ITEM NUMBER	6.4
SUBJECT	Planning Proposal for Land at 55-59 Kirby Street, Rydalmere
REFERENCE	RZ/26/2016 - D06629555
REPORT OF	Senior Project Officer
LANDOWNER	Fife Capital
APPLICANT	Mecone NSW Pty Ltd

The purpose of this report is to seek the Local Planning Panel's (LPP) endorsement to proceed with the Planning Proposal for land at 55-59 Kirby Street, Rydalmere in accordance with the Council Officer recommendations and recommend that Council forward it to the Department of Planning and Environment for Gateway Determination.

Figure 7. Site outlined in red showing the applicant's proposed 1.5:1 FSR

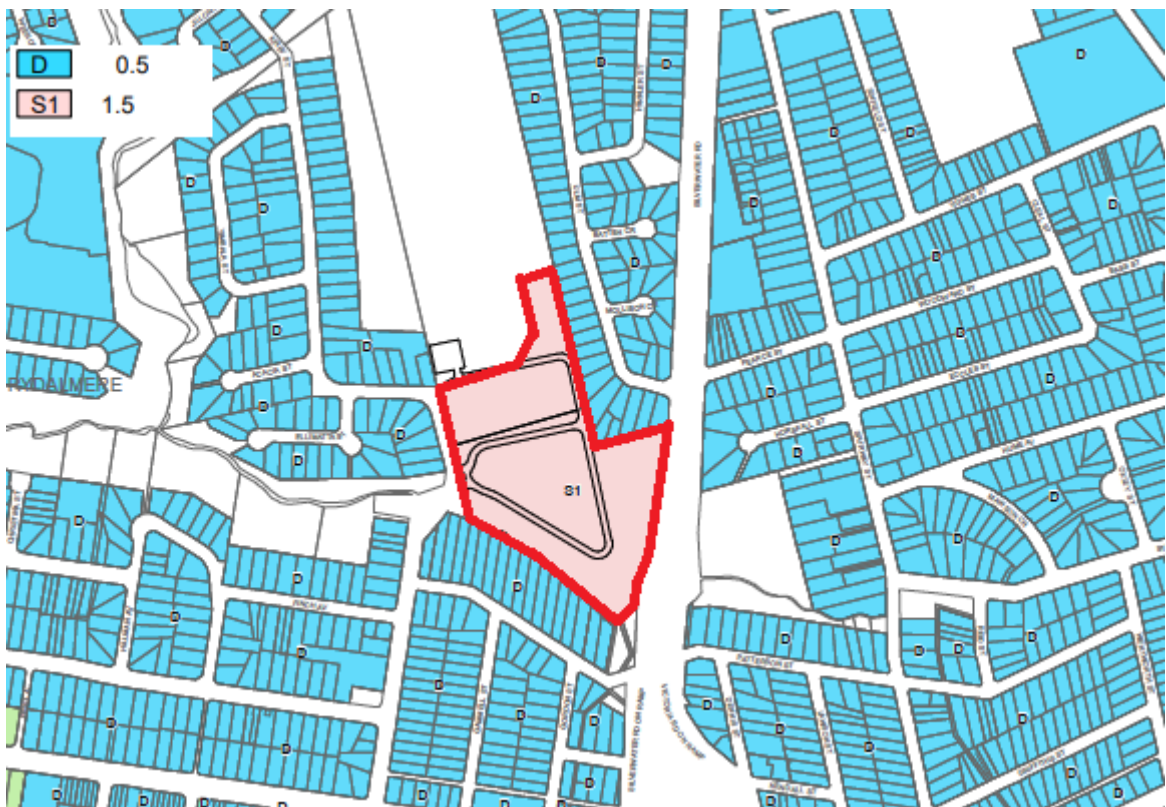
43. The applicant is proposing to increase the permissible floor space ratio (FSR) on the site from 1:1 to 1.5:1 and maximum building height of 31m. Council officers have raised significant concerns relating to this increase and do not support this change. The site is located within a low density residential area and such an increase will result in built forms that are not considered to be sympathetic to the existing character of the area. Council officers acknowledge that the site is suitable for some increase in density and an FSR of 1.3:1 and maximum building height of 20m is considered a more appropriate response by Council officers from an urban design perspective.

- (a) **That** Council resolve to proceed with the Planning Proposal for land at 55-59 Kirby Street, Rydalmere (provided at **Attachment 1**), which seeks the following amendments to Parramatta Local Environmental Plan (PLEP) 2011:

1. Rezone the site from IN1 General Industrial to R4 High Density Residential
 2. Increase the maximum height of buildings from 12m to 20m (6 storeys)
 3. Increase the floor space ratio from 1:1 to 1.3:1

Figure 8. Site outlined in blue showing the applicant's proposed 31m building height limit

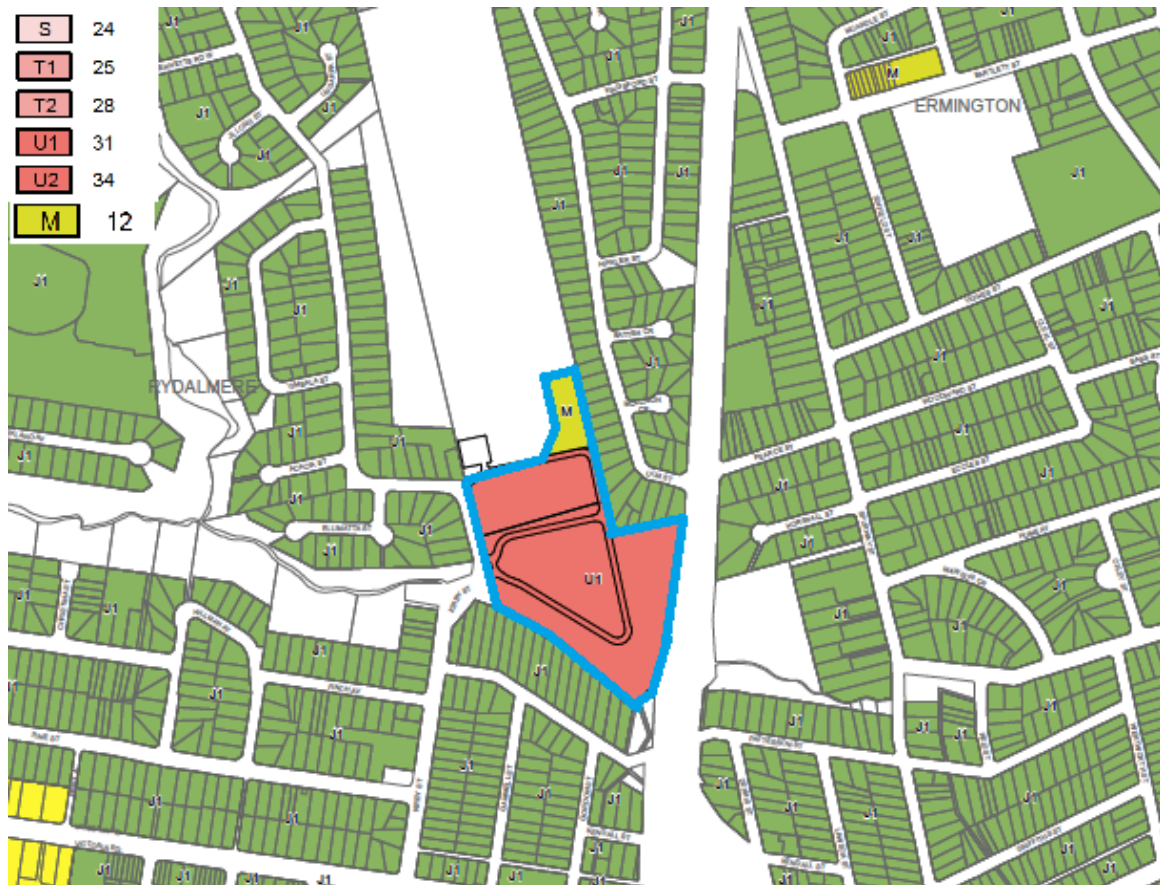
44. In addition, there is also a discrepancy between the number of storeys that can be achieved within 31m for high density residential development. The applicant is proposing a maximum of 8 storeys on the site, however it is possible to achieve a 10 storey development within 31m using Council's approach to converting a numerical building height to storeys. Feedback on the suitable FSR and building height has been provided to the Applicant on multiple occasions through the process, however the response has stated that redeveloping the site at an FSR of 1.3:1 is not feasible. Further detail on the feasibility matters is contained later in this report. Refer to **Figure 9** below showing the applicant's proposed scheme.

Figure 9. The Applicant’s proposed scheme

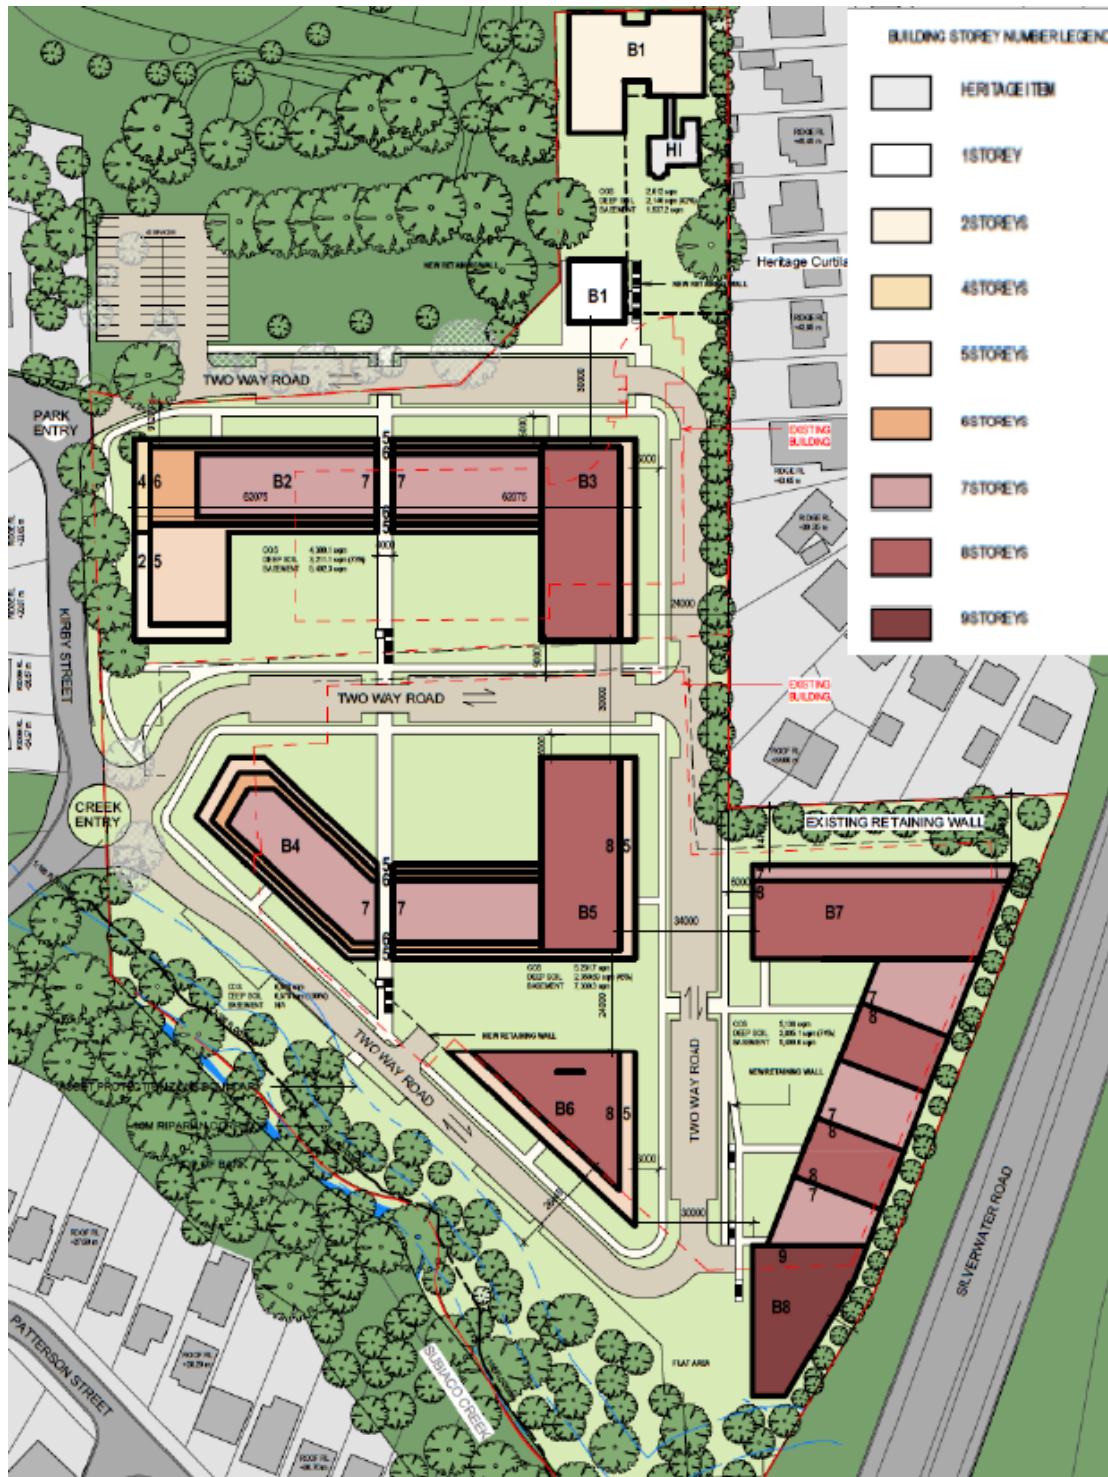
45. The site is relatively isolated and apart from the bus service on Victoria Road and small retail centre at Ermington, is not within close proximity to any major transport nodes or existing town centres that would typically be associated with development of the proposed density.

Figure 11. Council officers' preferred scheme

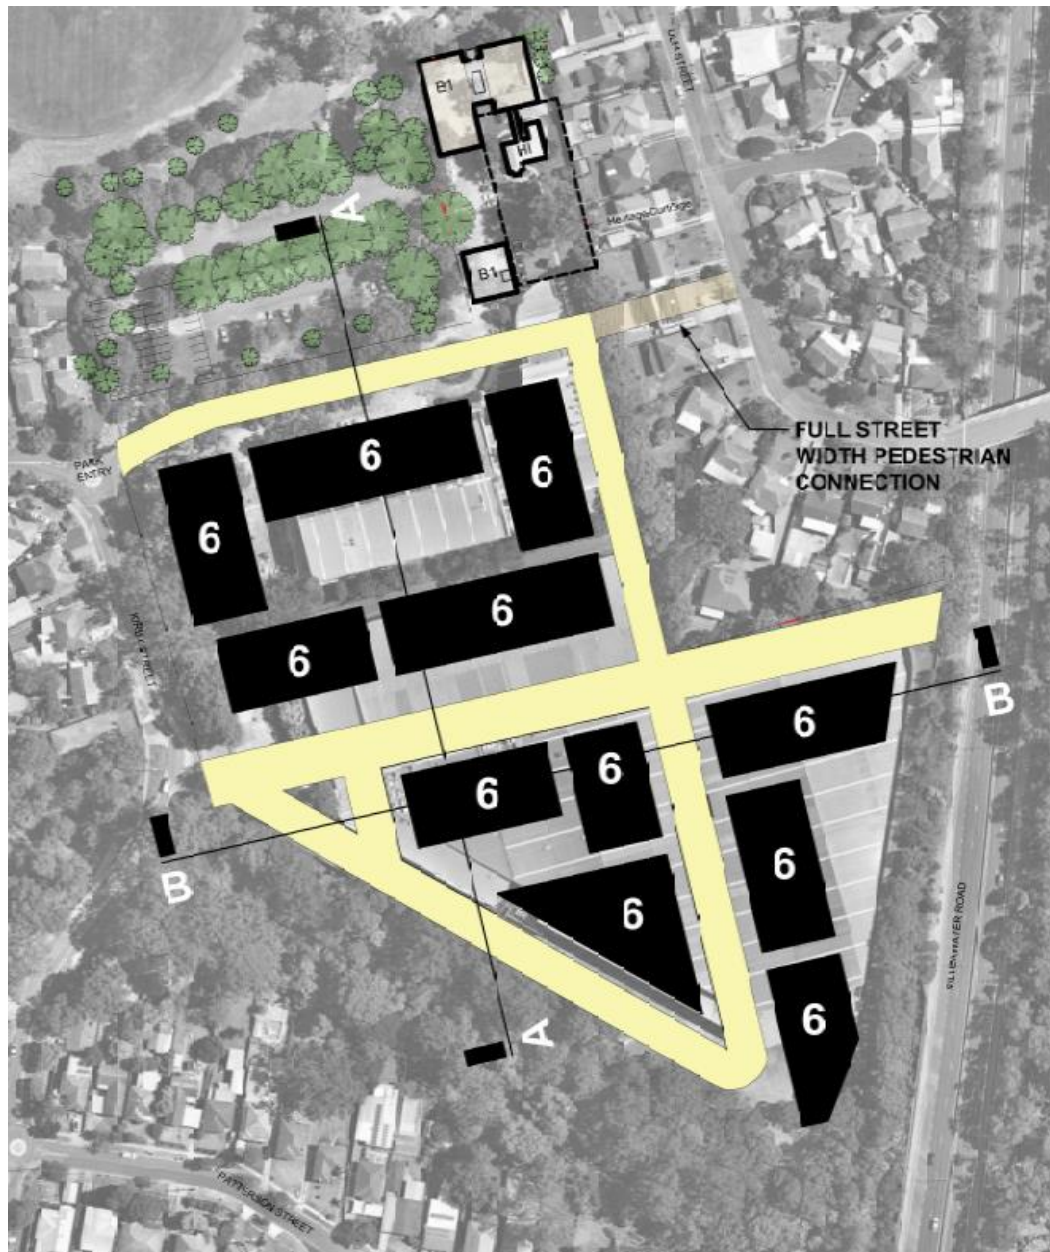
47. The built form of the development should address the street level and the central north-south through-site links need to clearly define public and private spaces. Major level changes need to be absorbed by the built form and walled street frontages are not supported. The reliance on steps, terraces and lifts to connect the public domain is also not supported. The constrained setback to the noise walls on Silverwater Road results in poor amenity and potential loss of tree canopy.

48. As a result, it is recommended a design with a block-layout that providing more centralised courtyards and a street-aligned building form with increased setback and a courtyard towards Silverwater Road is used instead. Refer to **Figure11** below for an indicative and preferred scheme that is considered to result in a better built form outcome for the site as it addresses the urban issues raised by Council officers. Note that a maximum building height of 6 storeys has been applied for visual purposes only and does not imply that this height is appropriate across the entire site.

Figure 12. Site sections comparing the two schemes

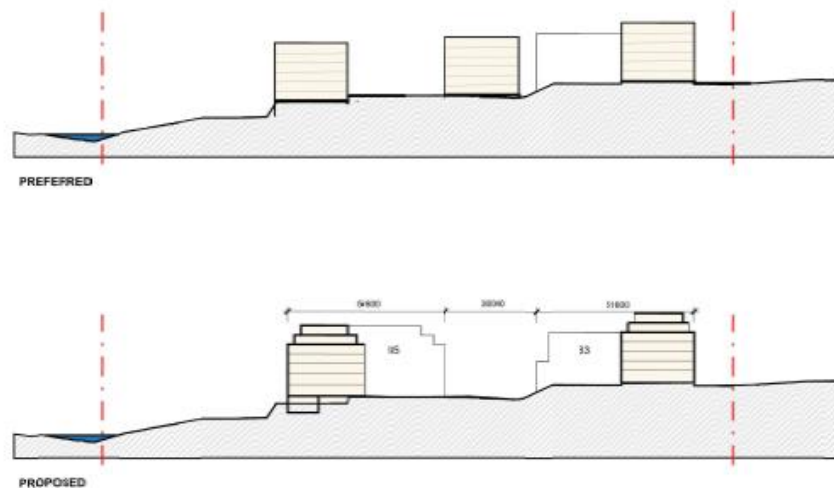
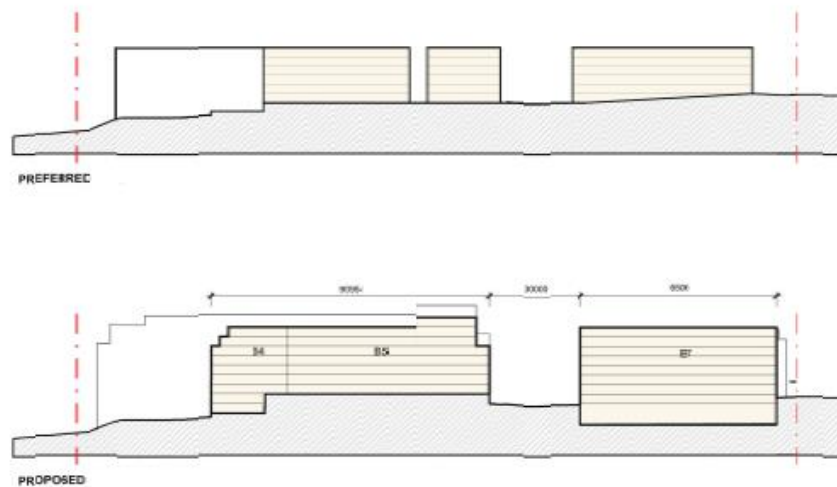
49. The two site sections contained in **Figure 12**, compare Council officers' indicative preferred scheme to the applicant's scheme from a north-south direction (Section A) and east-west direction (Section B). These sections highlight that the applicant's scheme produces a bulkier built form than that of the preferred scheme. The preferred scheme consists of a layout with smaller buildings on each block, which allows greater permeability across the site, improves the provision of communal open space by providing central courtyards and gives the impression of a less dense built form environment. It is considered this scheme produces a more appropriate response to the site and surrounding low density residential context compared to the applicant's.

Figure 14. Location of new roundabout providing access to the southern part of the site

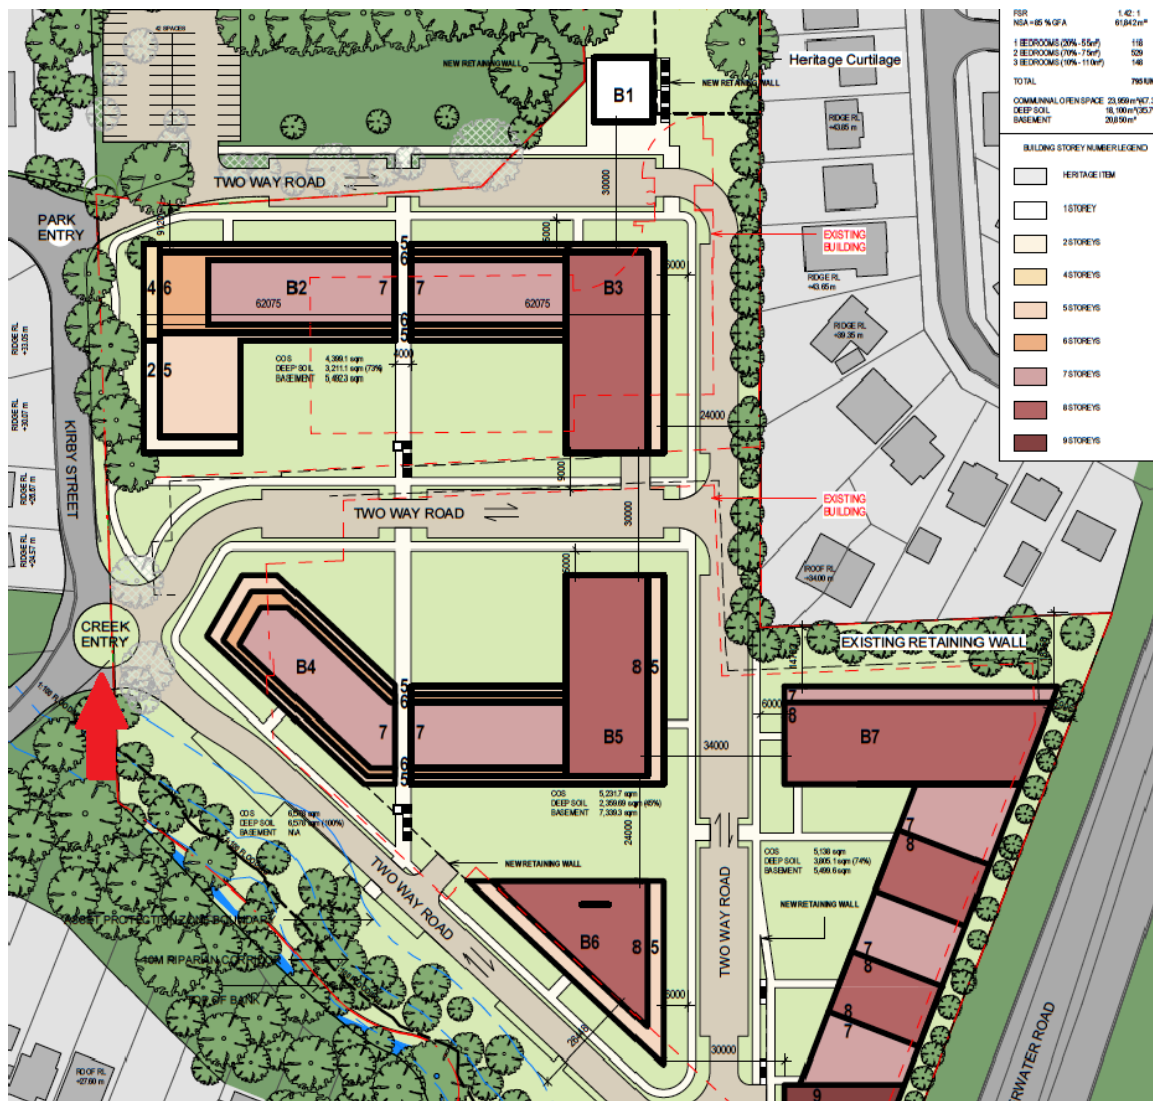
- 58. Existing site access is provided via a roundabout to 57-59 Kirby Street and is considered satisfactory. However, existing access to 55 Kirby Street at the southern end of the site is not considered suitable for any intensification of use due to its configuration (raised and semi-raised medians installed to reduce speed and corner cutting). As a result of Council officers' feedback, the applicant has amended the Proposal, identifying a new roundabout at this location. Council officers support this measure, however will need approval from the Parramatta Traffic Committee prior to construction. Refer to **Figure 14** below for the location of the new roundabout identified by a red arrow.

Figure 16. Location and extent of private access road located on Council-owned land

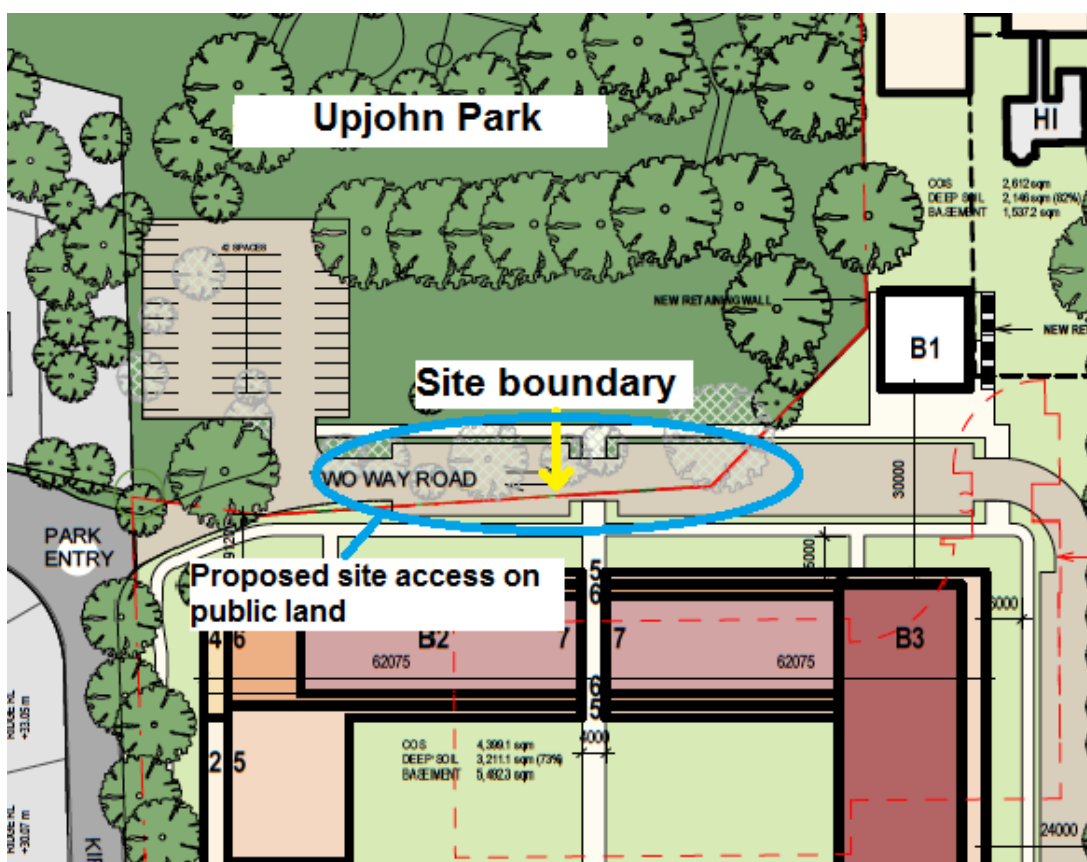
73. In order to resolve this issue, discussions between the applicant and Council officers took place where it was agreed that in order to rectify this issue, some public land could be used in order to improve site access to the park and car park as well as the subject site providing that upgrades to the existing car park and Upjohn Park were undertaken by the applicant. The current size of the Upjohn Park car park exceeds the needs of the park and the surplus space that was formerly used by the car park could be used to provide for better active recreation facilities, such as a hard court. As such, it is considered that some public benefit would be gained with this arrangement.

74. Although Council officers do not raise an issue with the use of some Council land for the road in principle to provide improved access to the park and car park, the extent of land proposed to be occupied requires some further refinement and it is recommended that this be undertaken by the Applicant to the satisfaction of Council as part of the DCP and VPA processes. Refer to **Figure 16** showing the location of the potential road circled in blue.
